M9805A-02

# Information Only Service Note

## M9805A PXIe Vector Network Analyzer

False alarm on self-test failure on firmware revision of A.13.40.02 - DDR3 memory removal

Self-test

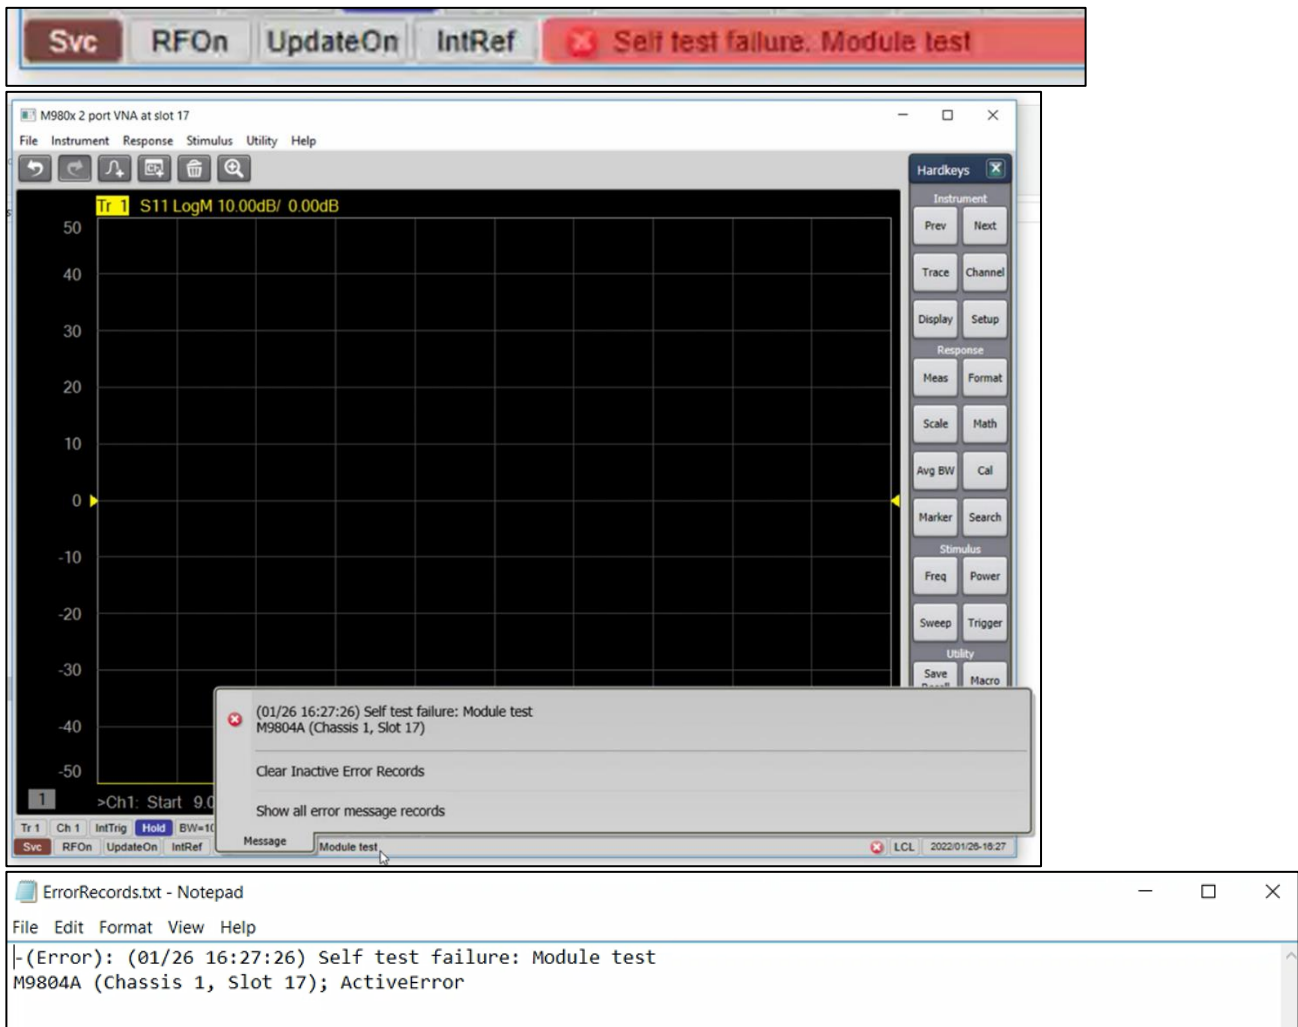
The on board DDR 3 memory in VNA is not in use since its release. With the removal of DDR 3 memory IC on newer M980xA VNA, right after firmware is launched, false alarm (self-test failure) will be reported as shown. This has no impact to VNA performance and specifications.

Similarly, firmware will report a false failure in Operator check. Shown are the error messages example on VNA firmware UI.

Since this DDR3 memory is not in use, newer firmware revision no longer consider it as the failure. Keysight recommends keeping VNA firmware up-to-date whenever it is possible.

For users with firmware revision of A.13.40.02,  
Update firmware to revision A.13.70.02 or newer to resolve this false alarm on self-test.
